Access Compliance Report

Public Rights-of-Way

(Curb Ramps)

Intersection ID: 10027081	Main Street: GALLERIA_BV	Cross Street: N/A	Location: NE
ADA ID: 5AB577B490AC	Ramp Type: PerpDiag	Initial Pass/Fail: Fail	Overall Compliance: No
		Severity Score: 42.5

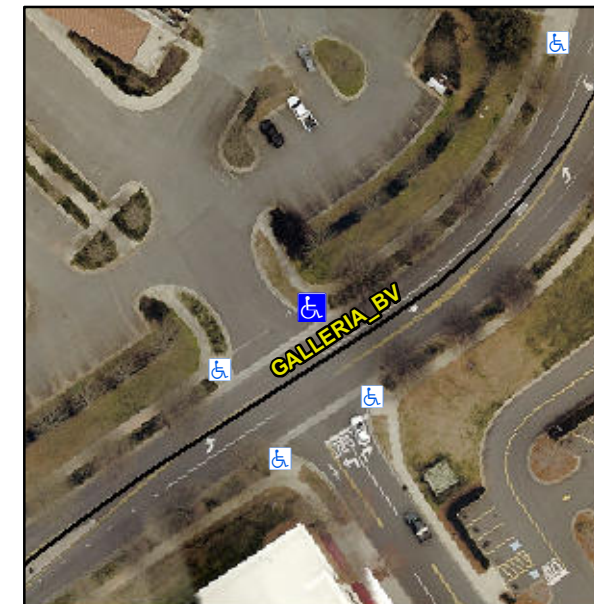
Not Found, R304.5.1, R304.2.2, R304.5.3

Compliance	Description	Data	Compliance	Description	Data
N/A	Ramp Length (in)	95.0	No	Ramp Slope (%)	10.4
No	Ramp Width (in)	34.0	No	Ramp XSlope (%)	6.0
N/A	Flare Type LT	N/A	N/A	Flare Type RT	N/A
N/A	Flare Slope LT (%)	N/A	N/A	Flare Slope RT (%)	N/A
N/A	Flare Traversable LT?	N/A	N/A	Flare Traversable RT?	N/A
N/A	Landing Length (in)	N/A	N/A	DWS Provided?	N/A
N/A	Landing Width (in)	N/A	N/A	DWS Contrast?	N/A
N/A	Landing Slope (%)	N/A	N/A	DWS Length (in)	N/A
N/A	Landing X Slope (%)	N/A	N/A	DWS Full Width?	N/A
N/A	Landing Curb? (Y/N)	N/A	N/A	DWS Offset (in)	N/A
N/A	Shared Landing?	N/A			
N/A	Gutter Ponding?	N/A	N/A	Gutter Slope (%)	N/A
N/A	Gutter Lip Ht (in)	N/A	N/A	Gutter X Slope (%)	N/A
N/A	Painted X Walk1?	No	N/A	Painted X Walk2?	No
	X Walk 1 Direction	To W		X Walk 2 Direction	To S
N/A	X Walk 1 Width (in)	N/A	N/A	X Walk 2 Width (in)	N/A
	X Walk 1 Slope (%)	0.3		X Walk 2 Slope (%)	1.2
	X Walk 1 X Slope (%)	3.0		X Walk 2 X Slope (%)	1.5

Remove & Replace Curb Ramp With Two New Directional Ramps or Equivalent.
